SALEM NUCLEAR GENERATING STATION, UNIT NO. 2

AMENDMENT TO FACILITY OPERATING LICENSE

Amendment No. 47
License No. DPR-75

ATTACHMENT TO LICENSE AMENDMENT NO. 47

Figure 3.4-2 Salem Unit 2 Reactor Coolant System Heatup Limitations
Applicable Up to 7 EFPY

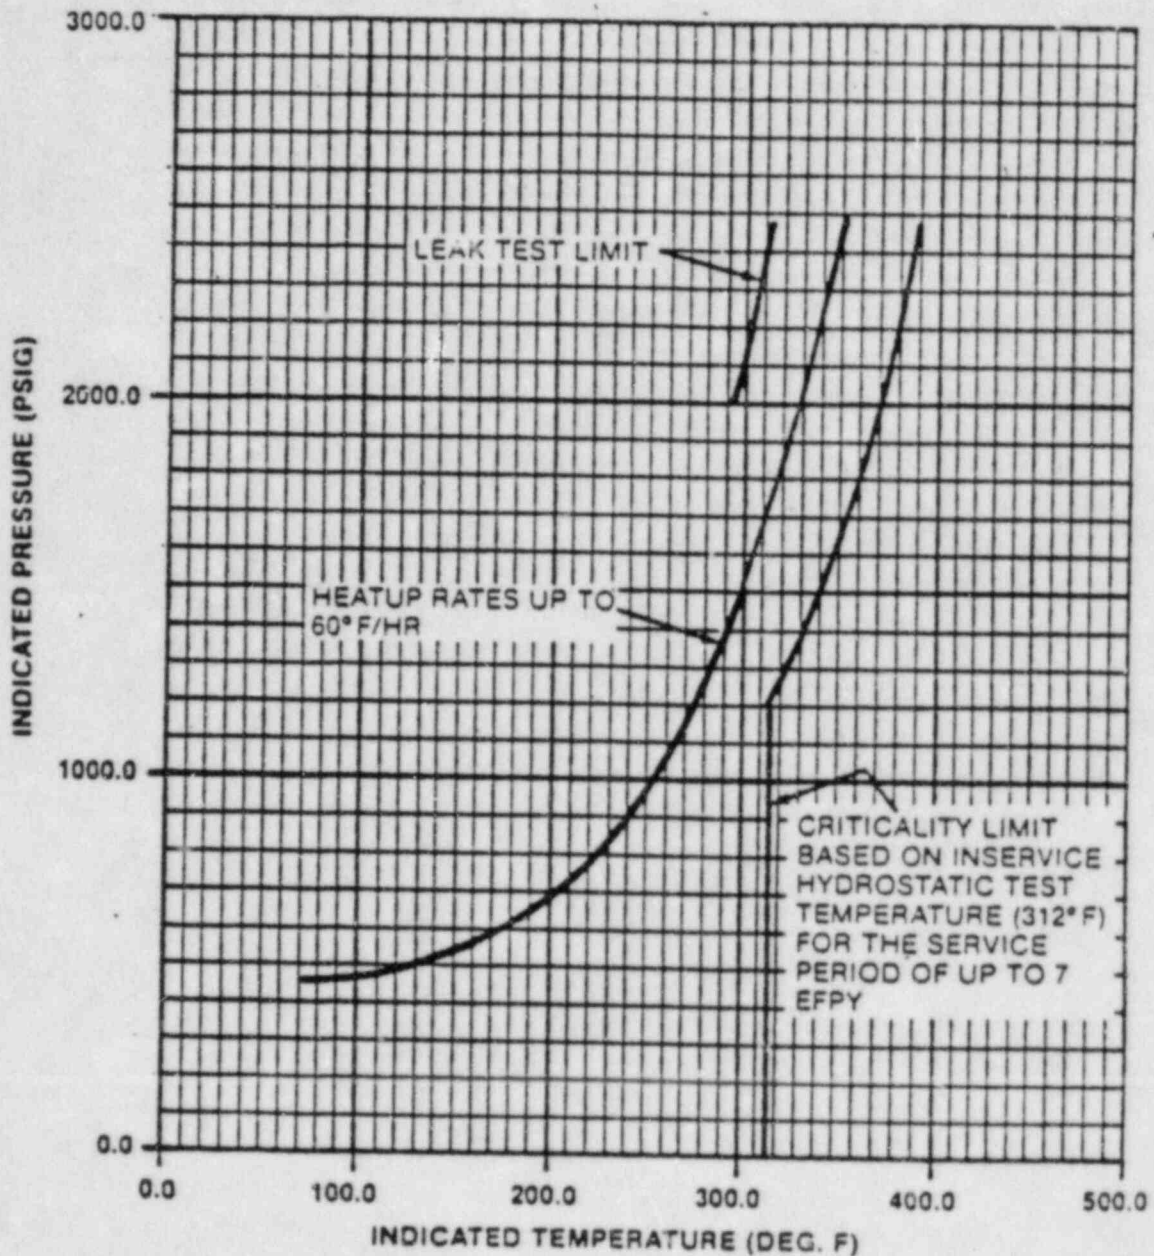
MATERIAL PROPERTY BASIS:

CONTROLLING MATERIAL : WELD METAL (UPPER BOUND OF REGULATORY GUIDE
TREND CURVE)
RT_{NDT} INITIAL : 0°F
RT_{NDT} AFTER 7 EFPY : 1/4 T, 16.7°F
 : 3/4 T, 75°F

CURVES APPLICABLE FOR HEATUP RATES UP TO 60°F/HR FOR THE SERVICE PERIOD UP TO 7 EFPY AND CONTAINS MARGINS OF 10°F AND 60 PSIG FOR POSSIBLE INSTRUMENT ERRORS

Figure 3.4-3 Salem Unit 2 Reactor Coolant System Cooldown Limitations
Applicable Up to 7 EFPY

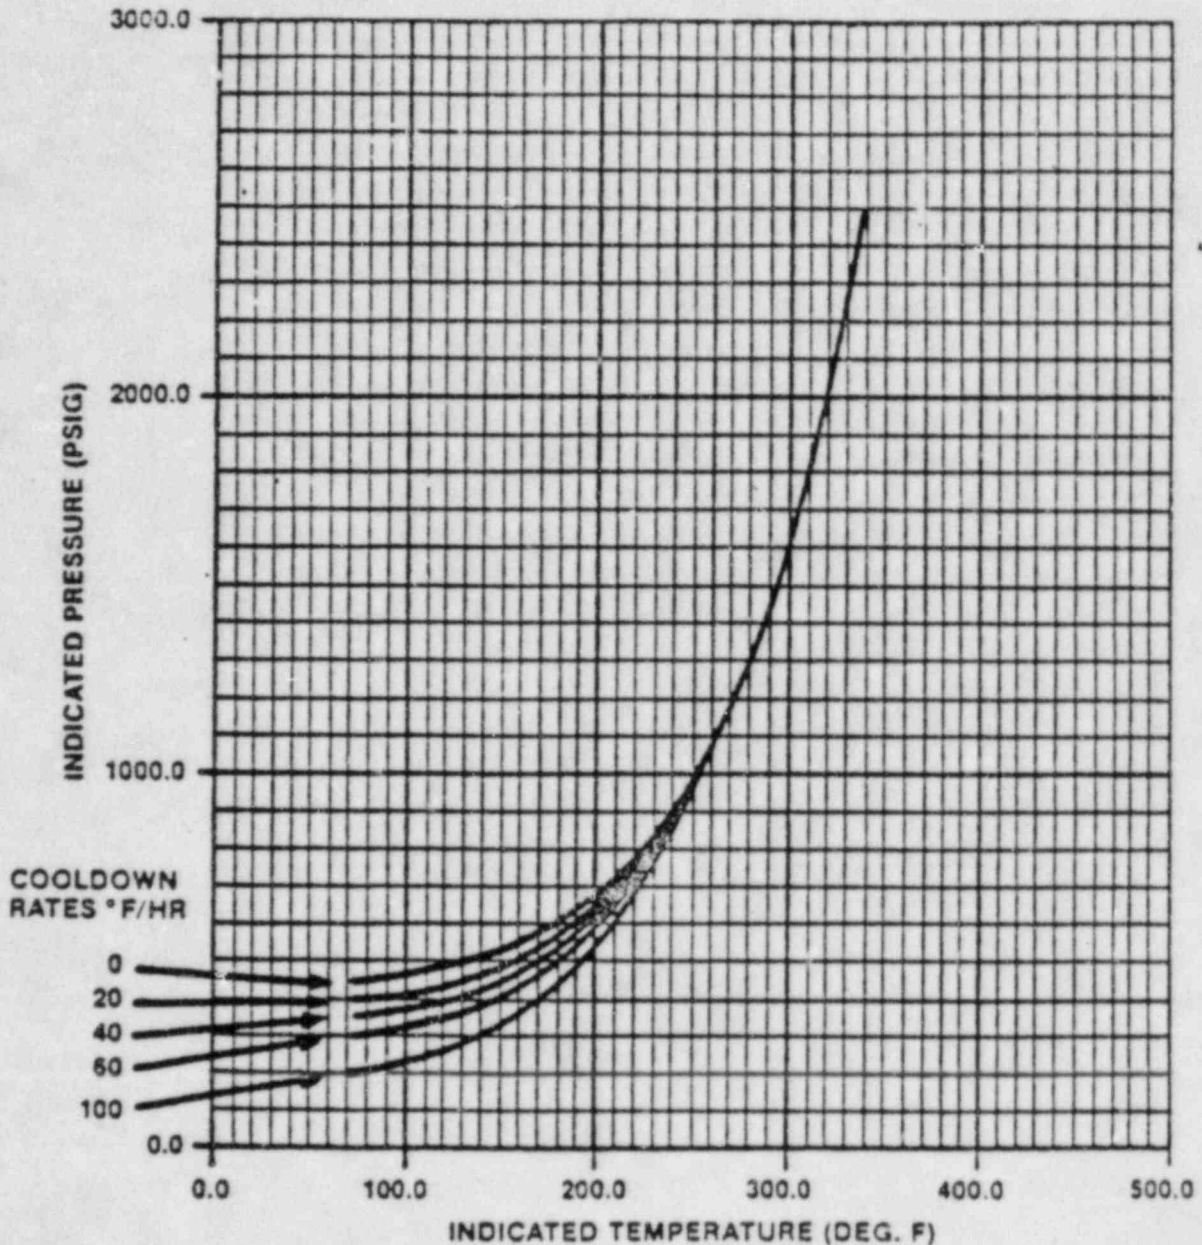
MATERIAL PROPERTY BASIS:

CONTROLLING MATERIAL : WELD METAL (UPPER BOUND OF REGULATORY GUIDE
TREND CURVE)

RT NDT INITIAL : 0°F
RT NDT AFTER 7 EFPY : 1/4 T, 167°F
 : 3/4 T, 76°F

CURVES APPLICABLE FOR COOL DOWN RATES UP TO 100° F/HR FOR THE SERVICE PERIOD
UP TO 7 EFPY AND CONTAINS MARGINS OF 10° F AND 60 PSIG FOR POSSIBLE INSTRUMENT
ERRORS
